STAFF REPORT

SUBJECT: H-2020-0074
TM Center - PP
Ten Mile Crossing – MDA, RZ

I. PROJECT DESCRIPTION

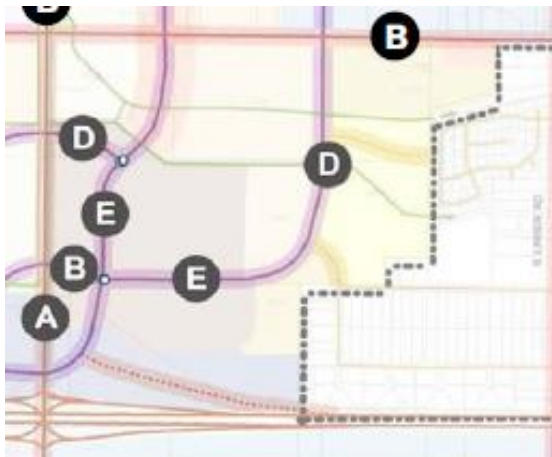
Two (2) driveway accesses via Franklin Rd. are depicted on the plat – one to the east and one to the west of New Market/Benchmark on Lot 4, Block 3 and Lot 4, Block 4. The conceptual

development plan included in the DA for the Bainbridge Franklin property depicts the eastern driveway access via Franklin; however, the Applicant states this property is no longer planned to develop in that manner. ACHD has *not* approved either of these accesses and is requiring a traffic analysis be submitted to demonstrate additional driveways are necessary to serve the site. The UDC's ([11-3A-3](#)) intention is to improve safety by combining and/or limiting access points to arterial streets to ensure motorists can safely enter all streets. City Council should determine if a waiver to the standards in UDC 11-3A-3 is appropriate for the proposed driveway accesses in the absence of a conceptual development plan for this area. These accesses are prohibited unless specifically approved by the City and ACHD.

- l. Remove the two (2) driveway accesses depicted on the plat via Franklin Rd. on Lot 4, Block 3 and Lot 4, Block 4 to the east and west of New Market/Benchmark unless specifically approved by City Council through a waiver to UDC 11-3A-3, which limits access to arterial streets, *and by ACHD. City Council approved these two (2) driveway accesses; ACHD approval is still required.*

STREET SECTION: S. WAYFINDER AVE.

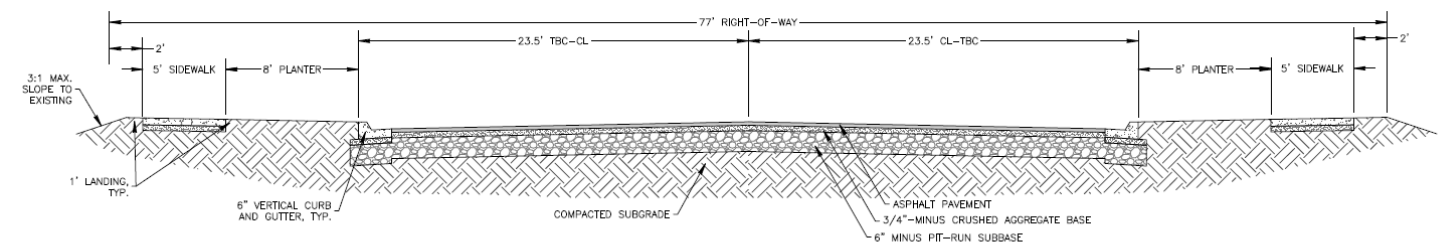
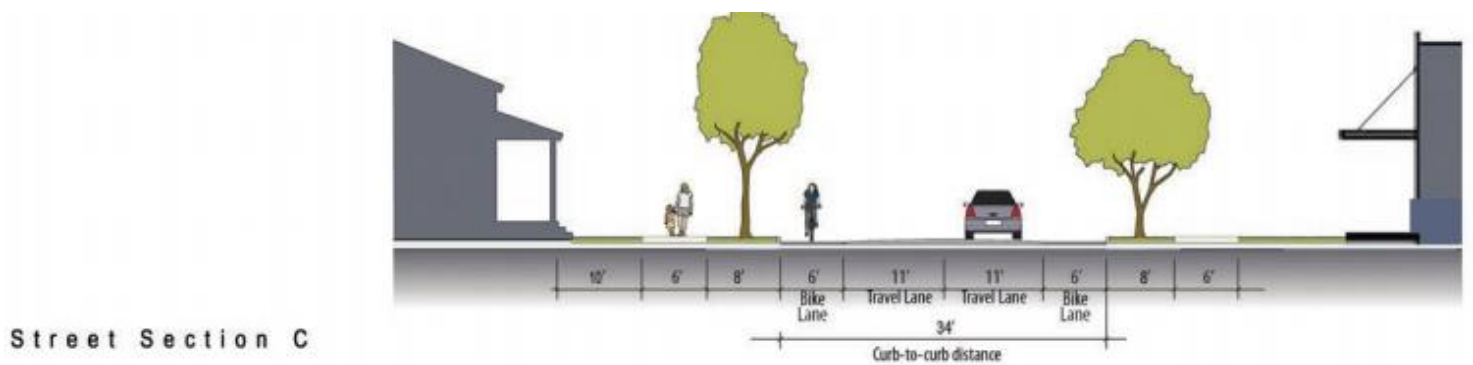
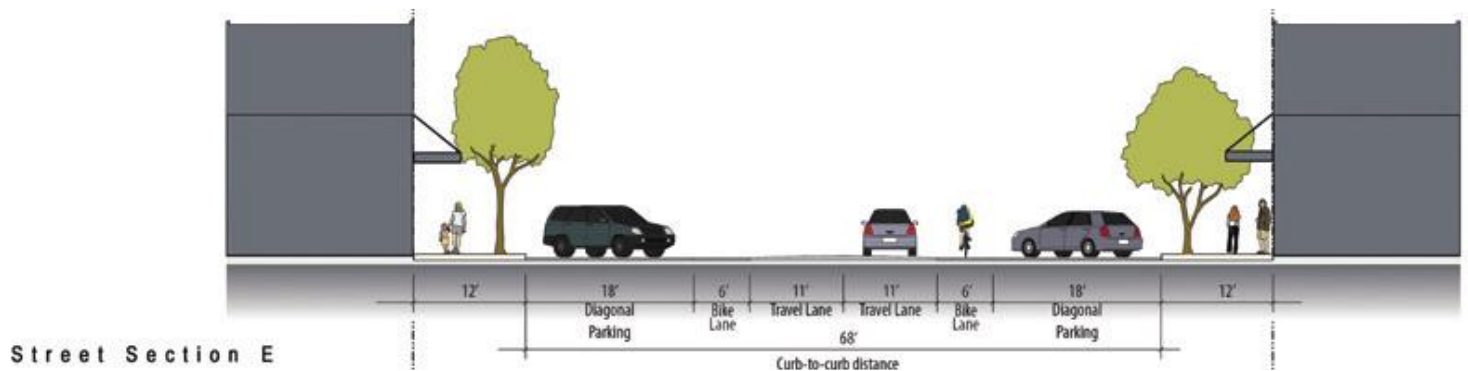
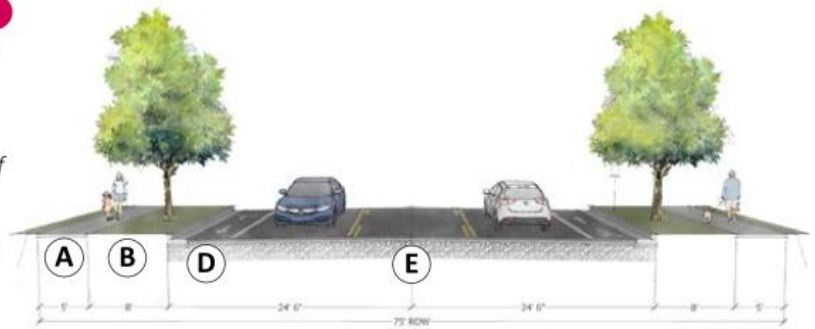
The western north/south collector street, proposed as S. Wayfinder Ave., designated as “E” (minor collector street), extends from a future signalized intersection at W. Franklin Road to the south to Vanguard. The portion north of Cobalt was approved with TM Creek subdivision. **Per the Map and as required by the existing DA for Ten Mile Center, this street should have been constructed per the guidelines for Street Section E shown below with two (2) travel lanes, bike lanes, diagonal parking and 12' sidewalks with trees in wells (see pgs. 3-21 & 3-23 in the TMISAP).** However, the street section approved by ACHD and constructed is a standard street section with (2) travel lanes, a center turn lane, bike lanes, 8-foot wide planter strips, a 5-foot wide detached sidewalk on the west side and an 8-foot wide pathway on the east side with no on-street parking, similar to that of major collector street (i.e. Street Section C, shown below) (see street section from the proposed plat and detail from the proposed design guidelines below). Because of the changes to the FLUM in this area from LC to Commercial and this street providing access to the employment uses to the south, which will likely result in a higher traffic volumes, Staff is in general support of the design as constructed. Minor collector streets in the Plan differ from the MSM's town center collector street in that they don't have a center turn lane and have diagonal instead of parallel parking.

Minor collector streets serve as the primary retail streets and are pedestrian-oriented and defined by street-level storefronts. Buildings are built to 12-foot wide sidewalks with street trees in wells and

pedestrian-scale lighting. A 5-foot wide dry-utilities corridor should be provided along both sides of the street curb; both wet utilities may be located in the street; and streetlights should be placed in the dry utilities corridor on either side of the street.

(4021) South Wayfinder Ave. shall initially be constructed in accord with the street sections shown below. Future reconfiguration of S. Wayfinder Ave. may occur if warranted by ACHD, in accord with the street section shown below.

STREET SECTION: S. NEW MARKET AVE.

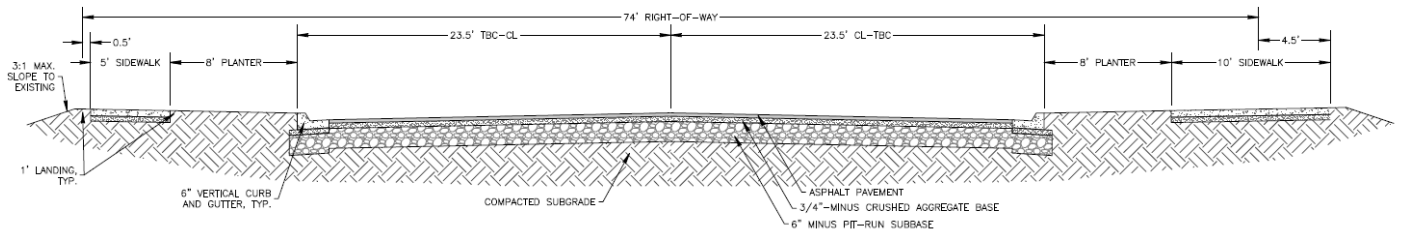
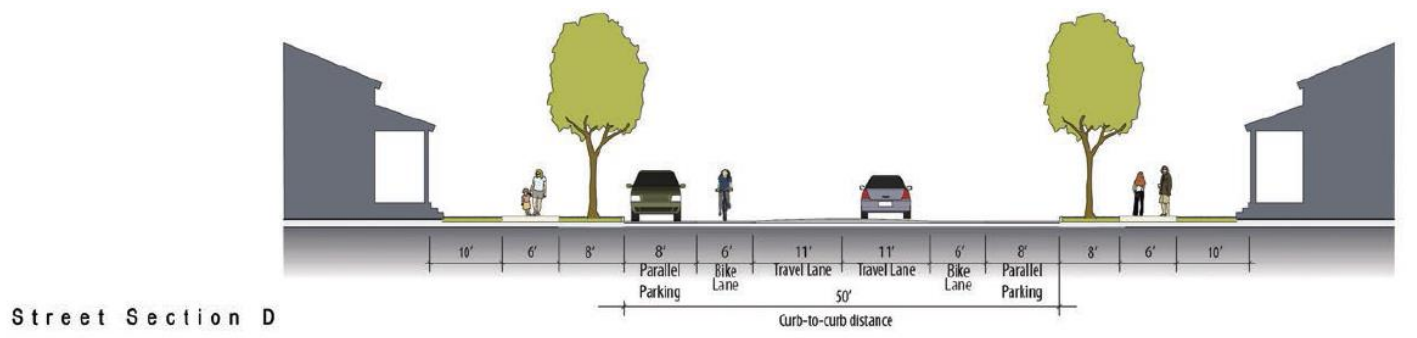
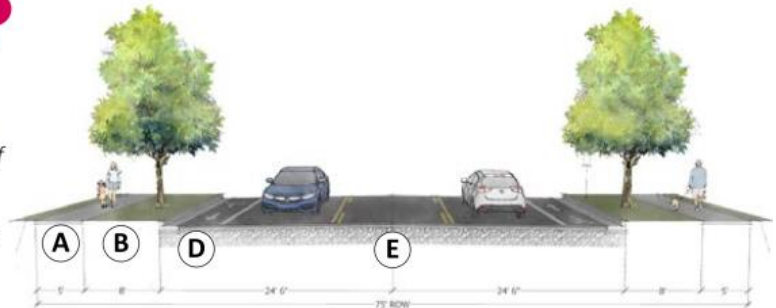
The eastern north/south collector street proposed as S. New Market Ave./Benchmark Ave., designated as “D” (residential collector street), will extend from Franklin Rd. to the south boundary of the site and connect to Navigator Dr. in the TM Crossing project. **This street should be constructed in accord with the guidelines for Street Section D shown below with two (2) travel lanes, bike lanes, parallel on-street parking (if allowed by ACHD), 8’ tree-lined parkways and detached sidewalks per the TMISAP and as required by the existing DA’s for Ten Mile Center and Calnon (see pgs. 3-21 & 3-23 in the TMISAP).**

The street section from the proposed plat and a detail from the proposed design guidelines shown below differ from a residential collector street in that there is a center turn lane, wider travel lanes and no on-street parking. ACHD has approved the proposed design; however, Staff does *not* support the proposed design as it’s not consistent with the TMISAP and the existing DA’s and therefore, recommends revisions consistent with Street Section D below with on-street parking. ACHD will have to review and approve revised street sections if changes are required to the proposed design – although on-street parking is desired and recommended, ACHD will need to review and determine if it’s safe to provide. *Staff discussed the discrepancies between the proposed plat and the town center collector in the MSM and Street Section D with ACHD and was told that although the Livable Street Design Guide allows for parking on a collector street it isn’t always appropriate in all locations – because we don’t know the end users for lots adjacent to these streets (a conceptual development plan or use plan wasn’t submitted) it’s difficult to determine if on-street parking will be appropriate. Residential collector streets in the Plan differ from the MSM’s town center collector street in that they don’t have a center turn lane and have a wider buffer zone.*

- ci. South New Market Ave./Benchmark Ave. shall be constructed with two (2) travel lanes, bike lanes, parallel parking south of Ten Mile Creek on the east side of the street, adjacent to future medium-density residential development (if allowed by ACHD at preliminary platting of that area), 8-foot wide parkways and detached sidewalks/pathways consistent with ~~Street Section D in the TMISAP~~ the Ten Mile Crossing Design Guidelines, the development agreement, Pathways Master Plan and pathway plan for the site. *The first 200' of south of Franklin Rd. on New Market is not allowed to have on-street parking per the ACHD report to allow for right and left turn lanes.*

STREET SECTION: W. COBALT DR.

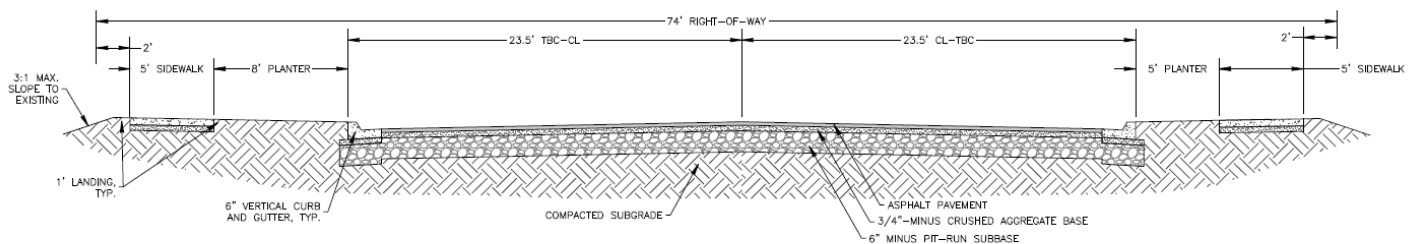
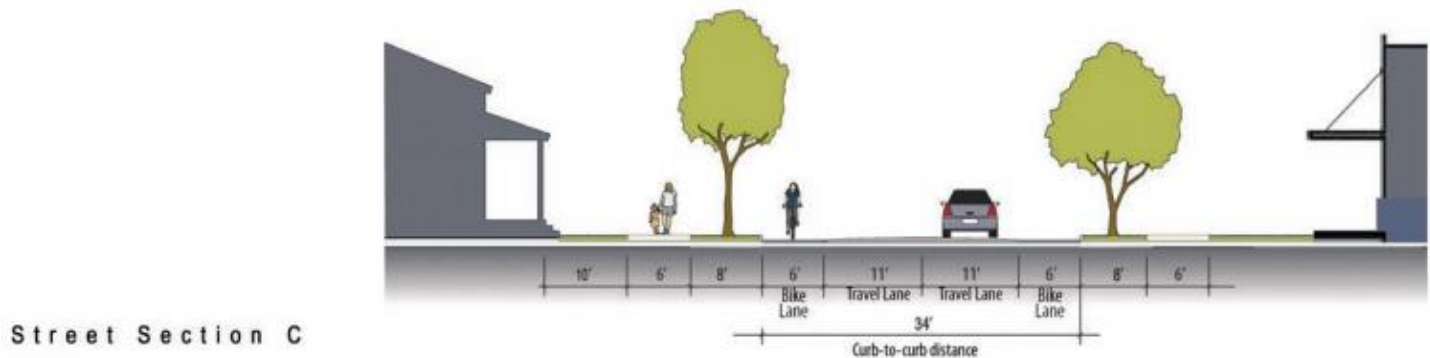
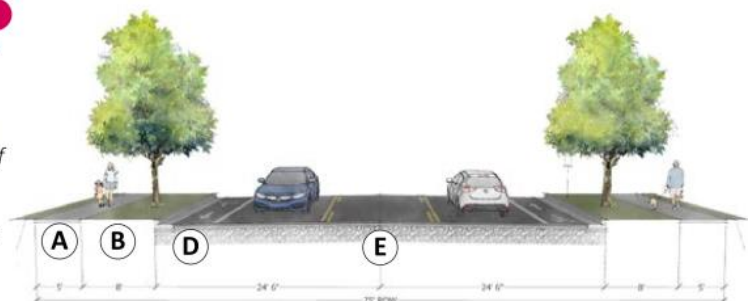
Neither the SSM shown above, nor the MSM, depicts an east/west collector where W. Cobalt Dr. is proposed to extend between Wayfinder and New Market although it does depict such further to the south in alignment with the access via Ten Mile Rd. along the southern boundary of this site which was actually constructed further to the south (i.e. Navigator Dr.) as discussed above. This southern section is designated as a minor collector street ("E") on the Street Section Map in the TMISAP and as a town center collector on the MSM. The portion of Cobalt west of Wayfinder is designated as a residential collector street (Street Section D) but was approved to be constructed as a major collector street closely aligning with Street Section C due to residential uses not being planned at that time in that area – since that time, the development plan changed and multi-family residential uses have been constructed along the north side of the street, east of S. Innovation Ln.

The extension of Cobalt will provide a connection from Ten Mile between Wayfinder and New Market/Benchmark, which Staff believes provides much needed connectivity in this area. Residential

uses exist and are planned on the north side of this street between Wayfinder and New Market/Benchmark with future commercial uses likely on the south side. The section of this street east of TM Creek East Apartments has not yet been constructed but the design has been approved by ACHD with the subject plat. Staff is amenable to the proposed design consistent with that constructed to the west.

Street Section C, the street section from the plat and a detail from the proposed design guidelines are shown below. The western portion of Cobalt in front of the TM Creek East apartments project was previously approved as part of ACHD's action on that project and has been constructed.

- (10) ~~(31)~~ Future construction of streets within this site shall be consistent with the applicable street section as shown on the Street Sections ~~Map~~ contained in the Ten Mile Crossing Design Guidelines Interchange Specific Area Plan (TMISAP) (pgs. 3-20 and 3-21) with the exception of the east/west collector street (W. Cobalt Dr.) from Ten Mile Road at the northwest corner of the site which shall be constructed as a major collector street in accord with Street Section C.

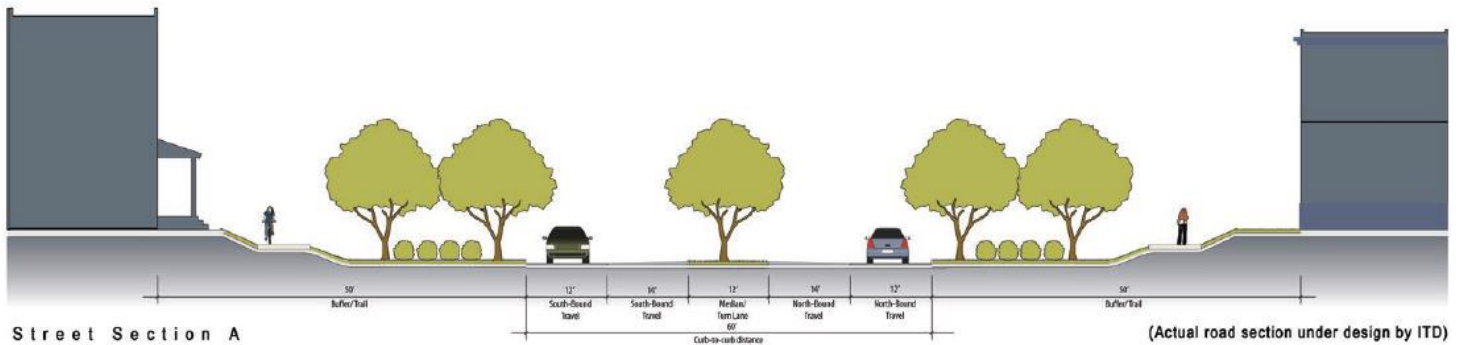
South Ten Mile Rd., an existing arterial street along the west boundary of the site, is designated as a modified 4-lane parkway (“A”) on the Street Section Map. **Buildings should address the street but be set back some distance from the roadway to provide security to the pedestrians and bikes and a wide tree lawn and detached trail should be provided as shown on Street Section A below. Streetlights should be located in the tree lawn area and should be of a pedestrian scale. Dry utilities should be located back of the curb in the dry utilities corridor.**

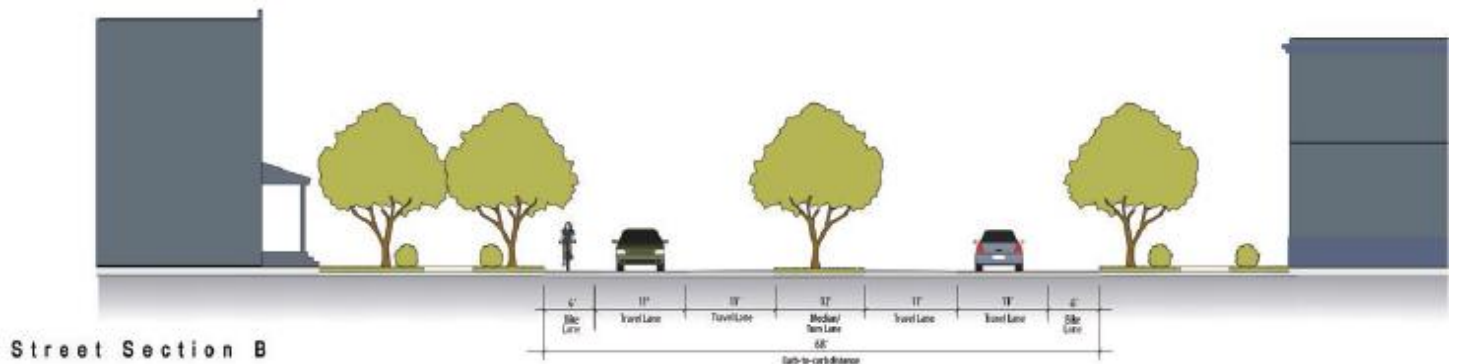
West Franklin Rd., an existing arterial street along the north boundary of the site, is designated as a typical 4-lane parkway (“B”) on the Street Section Map. **Buildings should address the street but be set back some distance from the roadway edge to provide for a tree lawn and detached sidewalk to provide security to the pedestrian as shown on Street Section B below. Streetlights should be located in the tree lawn area and be of a pedestrian scale. Dry utilities should be located back of the curb in the dry utilities corridor.**

- (9) Street lights ~~at a pedestrian scale~~ shall be installed within the tree lawn area along W. Franklin Rd. ~~as set forth in the TMISAP.~~
- (10) The Applicant should follow the bubble plan concept presented at the hearing, included in Exhibit VIII.H, as they move forward with their conceptual development plans.
